Staff Report Memorandum

Subject: Bicentennial Park Improvements (Conditional Use Permit and Site Plan

530 E. 8680 S.

SPR07272023-006575

SITE NOTES:

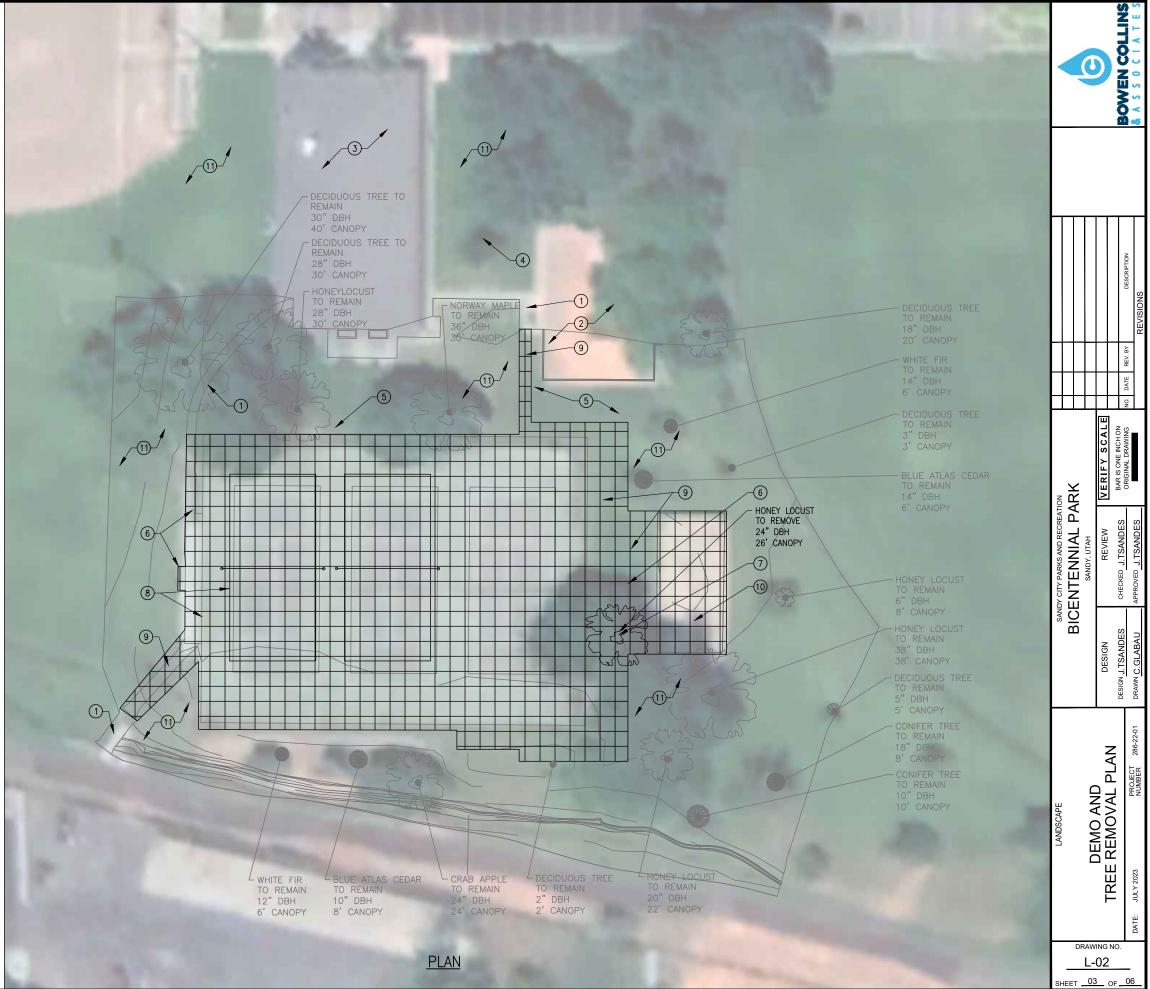
Staff is concerned about the removal of a mature tree on the site with no plan to replace it. Staff is recommending that the tree be replaced with other trees to help with noise mitigation.

- 1. That the applicant provide mitigation for noise and visual impacts from the proposed new outdoor recreation uses in the form of additional trees planted along the south side of the new pickleball courts.
- 2. That all activities and sports field/court lighting at the park be limited between the hours of 7:00 a.m. 10:00 p.m.
- #2 Staff recommends that the Planning Commission Planning Commission determine preliminary review is complete for the Bicentennial Park located at 530 E. 8680 S based on the following findings and subject to the following conditions:

- 1. That the applicant proceed through the final site plan review process with staff. The Final Site Plan shall be in compliance with all Development Code requirements, staff redlines, and those modifications as required by the Planning Commission.
- 2. That the development comply with all Building & Safety, Fire and Life Safety Codes applicable to this type of use.
- 3. That the applicant install a variety of trees along the south side of the pickleball court to replace the trees lost in the expansion of the courts and to provide mitigation of noise and visual impact. These additional landscape improvements must be shown in final site plan.
